# UNITED STATES PATENT AND TRADEMARK OFFICE

<b>Office Action Summary</b>	<b>Application No.</b> 10/536,576	<b>Applicant(s)</b> SZWAYKOWSKI ET AL.	
	<b>Examiner</b> Hwa S. Andrew Lee	<b>Art Unit</b> 2886

## DETAILED ACTION

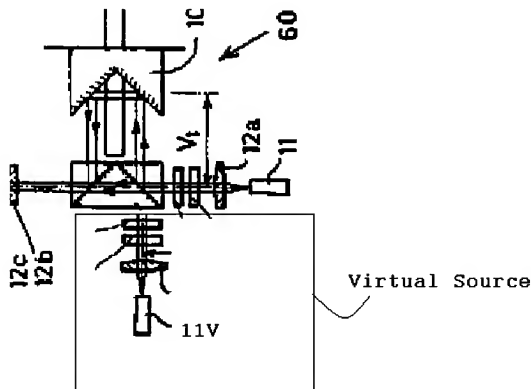
Kuchel show an interferometer for measuring optical phase differences (e.g. Figure 6) comprising:

a coherent light source module (11, 11V12a, and the first polarizing beam splitting mirror of 10a) for generating mutually orthogonally polarized beams of light, which are spatially displaced with respect to each other (beams are spatially separate in perpendicular direction from each other as they exit the first polarizing beam splitting mirror) and are in phase with one another, from spatially separated sources (please see

diagram below showing how there is a source (11) and a virtual source (11V) created by the beamsplitter. The source (11) and virtual source (11V) are spatially separated);

an interferometry module (1C, second polarizing beam splitting mirror of 10a, 12-16) receiving said mutually orthogonally polarized which are spatially displaced with respect to each other and are in phase with one another (at a moment the phase shifter is 1C is in a phase matched position), and temporally synchronized beams from said source module, and having at least a reference object (14) and a test object (16) for interaction with said beams; and

a simultaneous phase shifting module (68) receiving at least a portion of said beams from said interferometry module and generating at least two phase-shifted (67b) interferograms substantially simultaneously from said beams.
